**DESIGN COMMISSION  
MEETING**

**AGENDA**

PROJECT NAME <b>Sound Credit Union</b>	FILE NUMBER <b>PLN-2019-02354</b>	HEARING/MEETING DATE <b>January 8, 2020</b>			
STAFF CONTACT <b>Jason Sullivan</b>	PROPERTY OWNER <b>Sound Credit Union</b>	APPLICANT <b>Ben Warren</b>			
ADDRESS <b>20216 98th Street East</b>	TAX PARCEL(S) <b>0519036059</b>				
ZONING DESIGNATION <b>Midtown Core</b>	LAND USE DESIGNATION <b>Midtown Core</b>	SUBAREA <b>Midtown</b>			
BRIEF SUMMARY OF REQUEST <b>Approval of a design review application under Chapter 14.95 of Bonney Lake (the "City") Municipal Code (BLMC). The design review is required for the construction of an approximately 2,540 square foot banking facility along with associated on-site improvements on a 0.95 acre property.</b>					
COMPREHENSIVE PLAN CONSISTENCY <b>The proposal is consistent with the City's Comprehensive Plan policies direction that Midtown will accommodate a variety of uses including high density residential, offices, restaurants, large regional grocery stores, specialty retail stores, and regional shopping centers.</b>					
DEVELOPMENT CODE CONSISTENCY <b>The proposal development is a permitted use and is consistent with applicabl

Figure 1: Site Plan

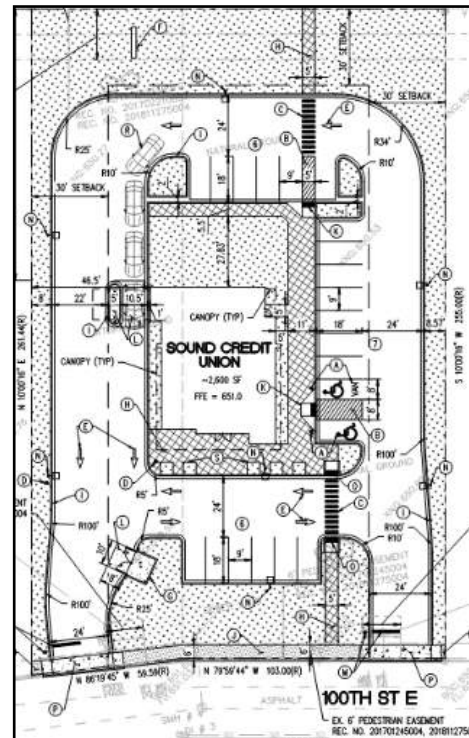
The site is a vacant level graded undeveloped 0.95 acre outlot with frontage on 98th Street East. The site plan in Figure 1 mistakenly identifies 98<sup>th</sup> Street East as 100<sup>th</sup> Street East.

Figure 2: Facade Buffering

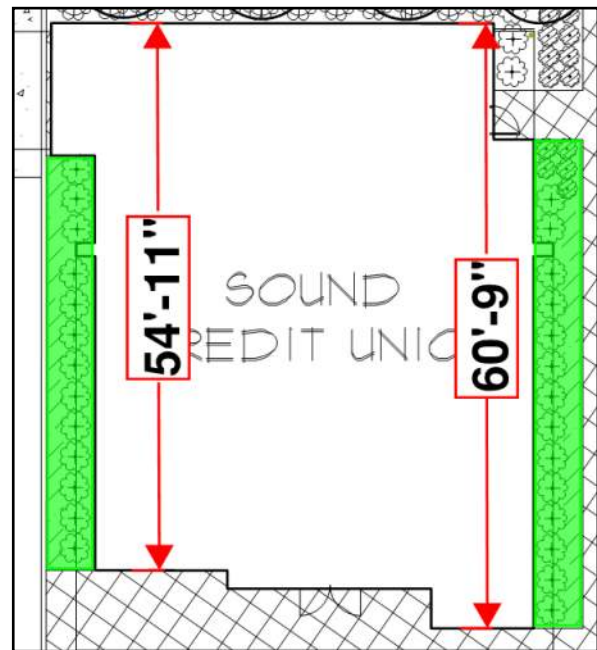
- Type III landscaping buffers<sup>4</sup> are required along building façades that are fifty (50) feet or more in length pursuant to BLMC 16.14.120. The eastern and western façades of the proposed building are both over fifty (50) feet in length. The landscaping plan<sup>5</sup> includes a Type III landscaping buffers along the eastern and western façades of the building. However, there are no trees within these buffers as required by BLMC 16.14.070. The layout is acceptable; however, a revised landscaping plan will need to be submitted with the building permit illustrating the required trees on the eastern and western façades. The northern and southern façades are less than fifty (50) feet; therefore, these façades are exempt from the Type III landscaping buffering requirement.

- 1.** The Applicant shall submit a revised landscaping plan as part of the building permit process to:
  - a.** Add the required trees in the Type III landscaping buffer on the eastern and western façade;

Figure 3: Parking and Maneuvering Areas

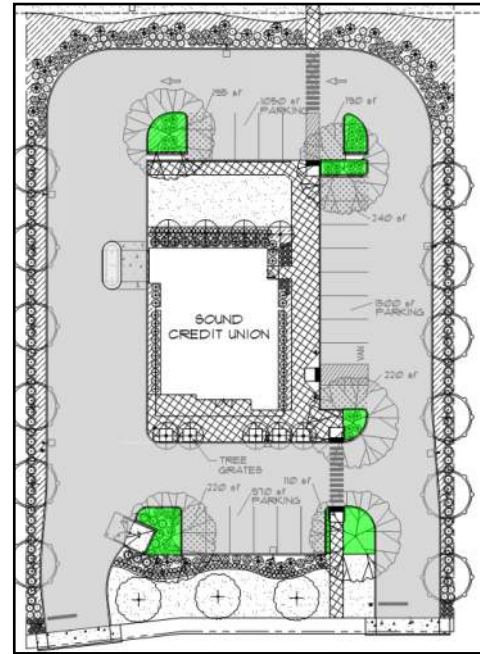
- At least five percent (5%) of surface area dedicated to parking and vehicular maneuvering areas, excluding the Type III landscaping buffers along the property lines shall be devoted to Type IV landscaping buffers to provide tree canopy pursuant to BLMC 16.14.100.B. The total area of the parking areas and vehicular maneuvering areas<sup>6</sup> is approximately 19,216 square feet. Five percent (5%) of this area would be 961 square feet. The landscaping plan shows six (6) Type IV landscaping areas within the parking lot<sup>7</sup> containing 891 square feet, which does not comply with the five percent (5%) requirement. Therefore, as part of the building permit, the Applicant shall provide a revised landscaping plan that includes an additional seventy (70) square feet of Type IV landscaping areas within the parking lot.

- A sufficient number, species, and distribution of trees are required to be provided so that upon maturity the tree canopy shall cover at least thirty percent (30%) of the parking and maneuvering areas, not counting receiving and refuse areas pursuant to BLMC 16.14.100.C. The total square footage of the parking and maneuvering areas is 19,216 square feet. The landscaping plan includes a statement that future tree canopy coverage will cover 1,175 square feet, which equates to approximately six percent (6%) of the parking and maneuvering areas. The project does not comply with the minimum requirement; therefore, as part of the building permit submittal, the Applicant shall provide a revised landscaping plan that provides additional tree canopy and includes an illustration of the mature tree canopy over the parking and maneuvering areas to demonstrate that the requirement is met.

<sup>6</sup> These areas are highlighted in gray on Figure 3

<sup>7</sup> These areas are highlighted in green on Figure 3

- b.** Provide an additional seventy (70) square feet of Type IV landscaping areas within the parking lot; and
  - c.** Provide additional tree canopy and an illustration of the mature tree canopy over the parking and maneuvering areas.
- 2.** Revise the lighting plan so that it is consistent with the re-orientation of the building and so that at no point do the onsite lumens exceed 6.0 lumens.
- 3.** All exterior lighting shall be dark sky complaint.

Figure 2

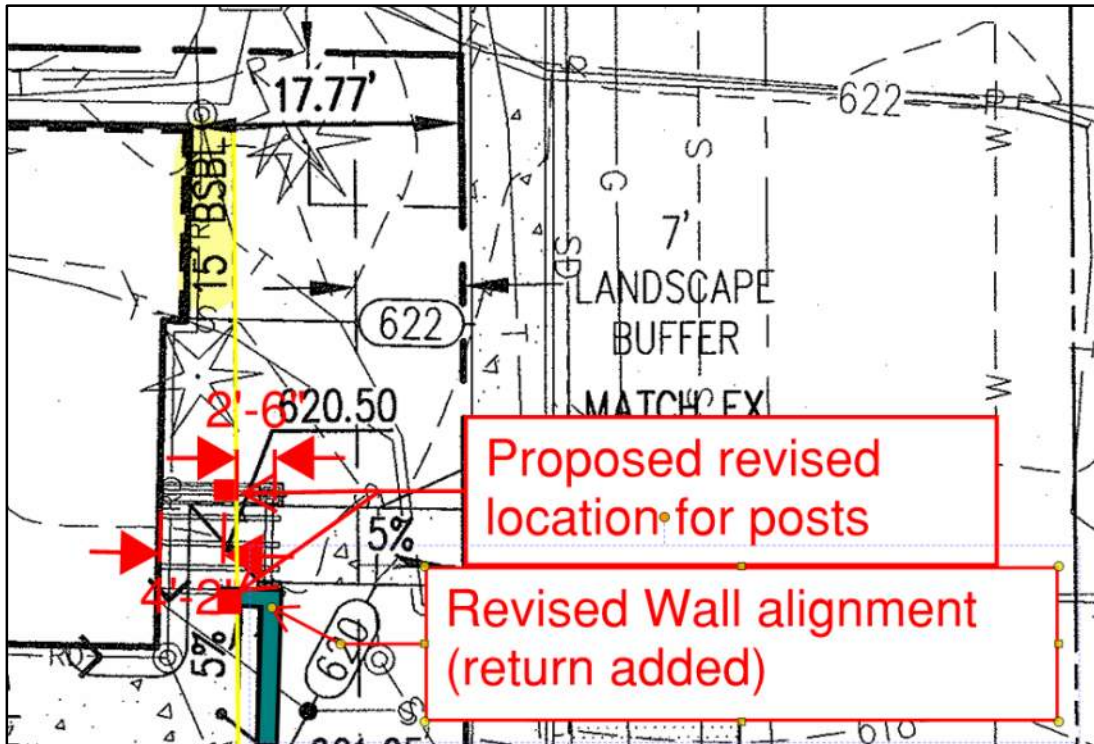
Since the downtown design standards require the addition of a decorative courtyard entry feature like the one being proposed, but the proposed horizontal posts encroach into the required front setback, City staff feels that it is appropriate to approve the design of the feature being proposed, but to require that the structural elements be modified to meet the setback requirement.

The proposed trellis can be brought into compliance with the setback requirement if the support posts closest to Locust Ave. E. (highlighted in the image above) are installed 15 feet back from the property line. The lateral elements of the trellis can still encroach into the setback up to a maximum of 30 inches, but the posts must be set back in compliance with the front setback requirement of the code. A prospective solution is represented in *Figures 2 and 3*, included below:

In the proposal represented in *Figures 2 and 3* above, the posts (represented as two red squares) are moved back behind the 15 foot setback that is required, and the 2' 6" (30 inches) overhang of the

horizontal structural elements extend into the setback in a way that is allowed under BLMC 18.22.080<sup>2</sup>. This proposal is only intended to provide one example of how the front setback requirement might be accommodated with minimal changes to the overall design of the proposal—City staff recommends that the trellis be retained as a part of the approval with minor modifications that bring it into line with the requirements of the code.

Figure 4

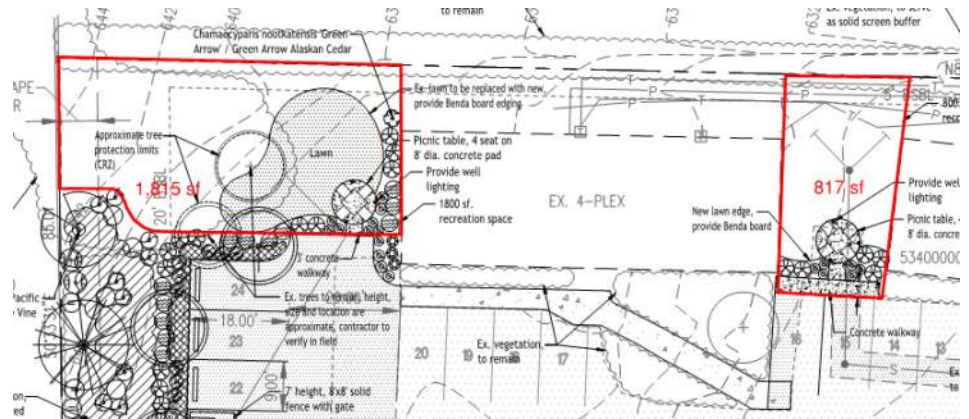
The proposal designates two areas of the site as the “developed recreational areas,” and the combined area of these two areas of the site meets the minimum required (see *Figure 4*); however, it is the opinion of staff that these two areas do not

meet the requirements related to being “developed for recreational use.” The applicant’s plans also refer to the courtyard adjacent to the new building as “480 sf. recreation open space,” but no description of what development features are involved or what recreation might take place there. Under the current proposal, each of the two recreation areas (other than the courtyard) would include a picnic table with attached seating. While this improvement might be adequate if provided in conjunction with a community barbeque facility, it is the opinion of the City that seats and tables on their own do not constitute developed recreational facilities. City staff feel that it is important that the developer provide additional recreational features such as a children’s play area with a ‘big-toy,’ a community gardening area, a barbeque shelter, or some other type of recreational development that will satisfy the requirements of this code section.

Figure 5 - NTS

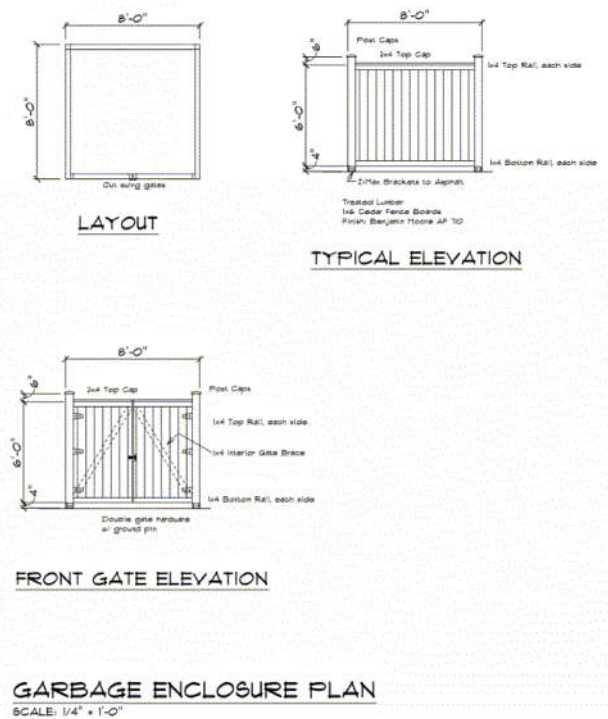
The **Exterior Building Materials and Color** section of the downtown standards (**section 4.4**) include specific requirements for the exterior construction materials used in building proposed structures within

Figure 6

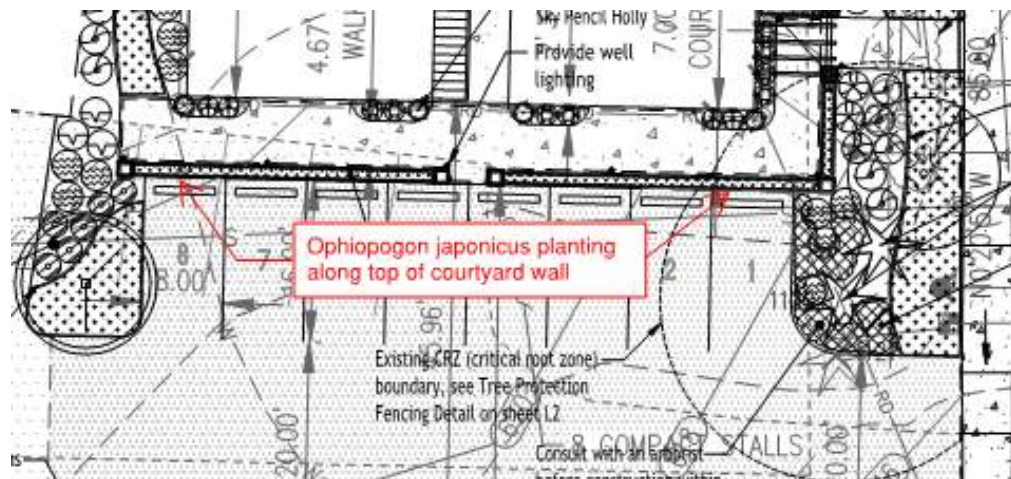
The current landscaping proposal meets the requirements of BLMC 16.14.170.B. The site has plenty of trees (more than the minimum of one tree per 3,000 square feet of paved area) within close proximity to the new/revised parking areas provided as required. In addition, there is an existing fully-screening hedge on the southern property line that has grown over an existing low fence that fully shields the apartments to the south visually from the parking area for this development. The other requirements of BLMC 16.14.170 are also met, and the only one that bears discussion is BLMC 16.14.170.D.3 as it relates to the parking area abutting the courtyard adjacent to the new building. In that location, the requirement for the perimeter parking area landscaping requires an L-2 standard (low screen) landscape buffer. The L-2 standard description in BLMC16.14.070.B.2 allows for the use of a “masonry wall, solid wood fence, or a berm between 30 and 42 inches high” as a substitute for low shrubs. The wall that is being installed to create the courtyard will shield the new residential building from headlights as vehicles pull in to park after dark, and will also function as a container to include attractive plantings of ‘*Ophiopogon japonicus*’ along the top, as shown below in *Figure 6*.
